PIC16F73/74/76/77

PIC16F73/74/76/77 Rev. B1 Silicon/Data Sheet Errata

The PIC16F73/74/76/77 Rev. B1 parts you have received conform functionally to the Device Data Sheet (DS30325B), except for the anomalies described below.

FIGURE 1: CRYSTAL/CERAMIC RESONATOR OPERATION (HS, XT OR LP OSC CONFIGURATION)

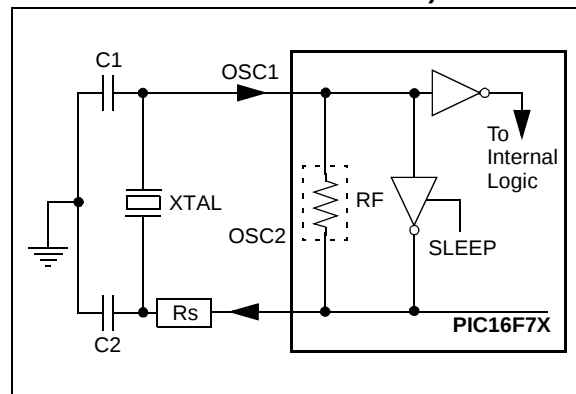
When resonators above 2 MHz are used, the HS mode oscillator is required to ensure reliable operation. HS mode oscillator drive at frequencies from 2 MHz to 4 MHz is often excessive, resulting in the amplitude of the oscillator waveform exceeding V_{DD} and V_{SS} . In such cases, the waveform may experience distortion as ESD protection devices begin to operate on the OSC1 and OSC2 pins. This distortion appears as a non-sinusoidal waveform or clipping, and can generate substantial harmonics that may create excessive noise in the application.

The gain of the oscillator should be reduced by inserting a series resistance between the OSC2 pin and the resonator/capacitor as shown in the data sheet (see Figure 1). The value of the series resistance is dependant on V_{DD} , resonator frequency, and temperature; however, 330 ohms has been used as a good starting point for evaluation.

FIGURE 2: PINOUT DIAGRAM FOR PIC16F74/77, 44-PIN QFN PACKAGE

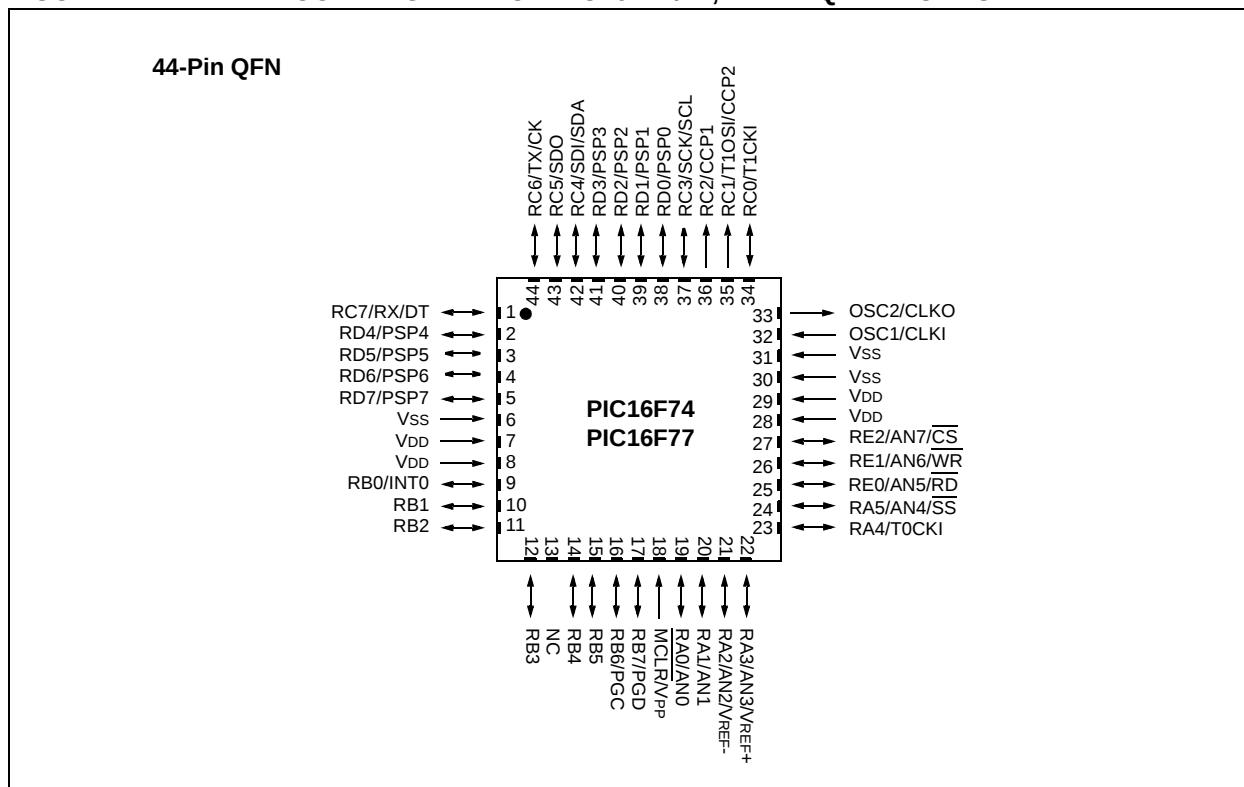
PIC16F74 and PIC16F77 devices are now offered in a 44-pin, micro lead frame package (commonly known as “QFN”). This provides near chip scale package size. This option is in addition to the 28-pin QFN packages already available for the PIC16F73 and PIC16F76 devices. The 44-pin QFN package has been added to the product line since the original publication of the Device Data Sheet.

1. The “Pin Diagrams” on pages 2-3 of the Data Sheet are amended with the addition of the 44-pin QFN pinout shown in Figure 2.
2. Table 1.3 of Section 1.0 (“Device Overview”) is replaced with an updated version which adds a column for QFN pin assignments. All new information is indicated in **bold**.

FIGURE 3: PACKAGE MARKING TEMPLATE FOR PIC16F74/77, 44-PIN QFN

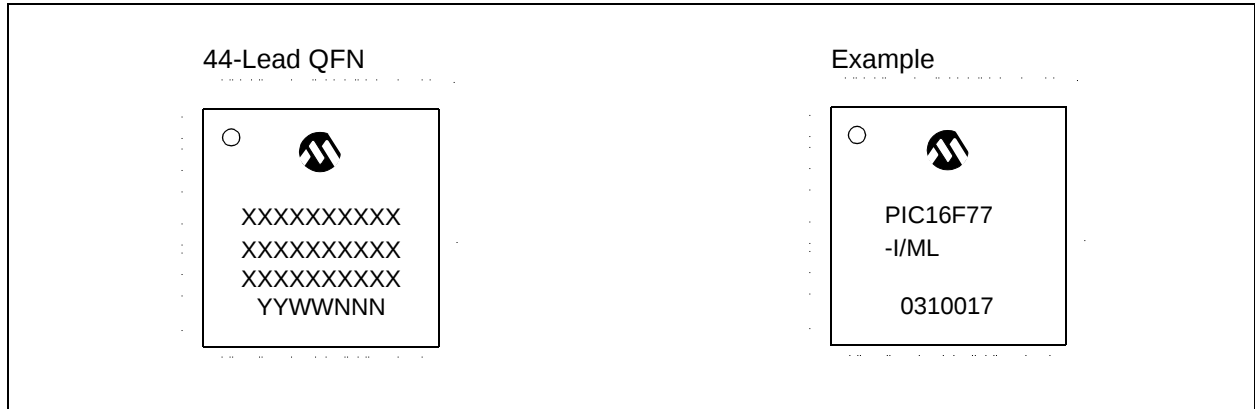
3. Section 17.1 (“Package Marking Information”) is amended to include a marking template and example for 44-pin QFN devices. These are shown in Figure 3.

FIGURE 4: 44-PIN QFN PACKAGE (DRAWING 1, PACKAGING)

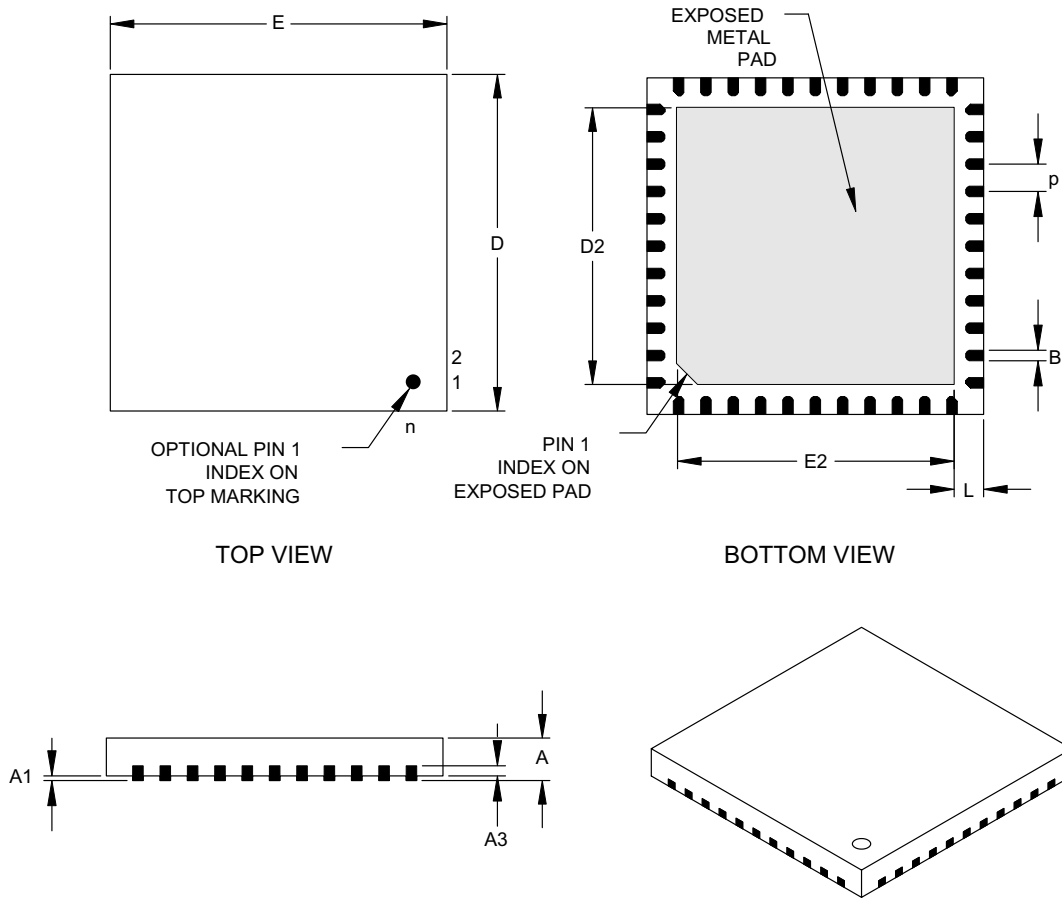
4. Section 17.2 (“Package Details”) is amended to include the mechanical drawing of the 44-pin QFN package, following the existing drawings. This is shown in Figure 4.
